May 14, 2019

## **Lower Mokelumne River Fish Screen Projects**

### **ADDENDUM NO. 2**

**Figure 4.** Photographs of Site #3 including; (A) the submerged diversion pipes in the river, (B) the pumping station, (C) location of the pipes connecting to the pumping station, (D) and an aerial view of Site 3.

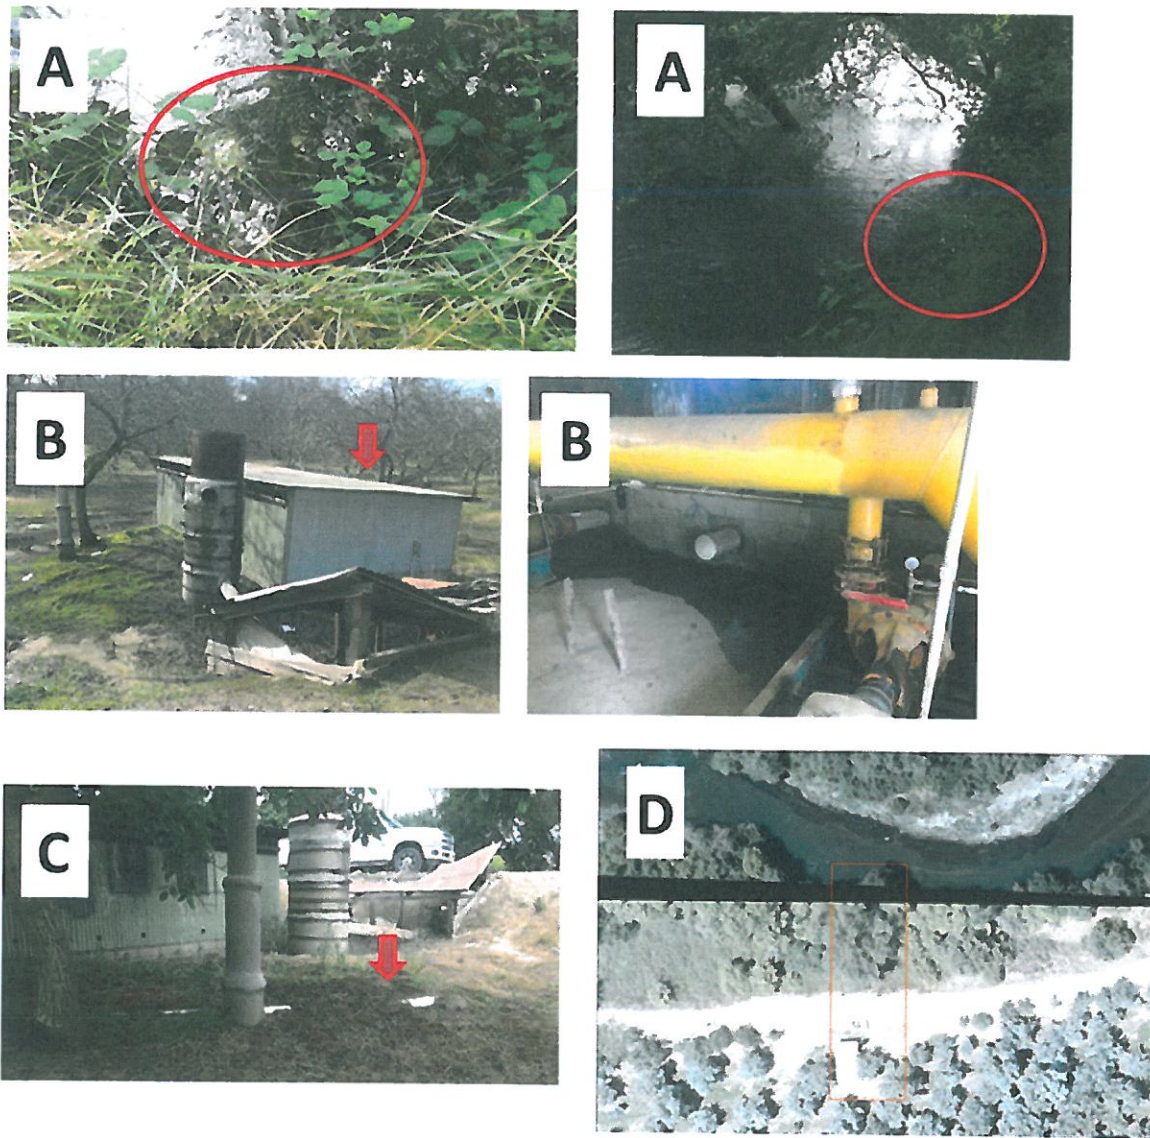
1. RFP Section I.C.2 - Project Site Information (Page 9) – **DELETE** Figure 4 in its entirety and **REPLACE** Figure 4 with the following photos and text:

Answer: Site 3 has two diversion pipes that extend from the river to the pumping station. The Site 3 description and photos (Figure 4) have been revised from the original RFP and addressed in this addendum.

Photographs of the submerged diversion pipes in the river (A), the pumping station (B), location of the pipes connecting to the pumping station (C), and an aerial view of Site 3 (D), are provided by Figure 4.”
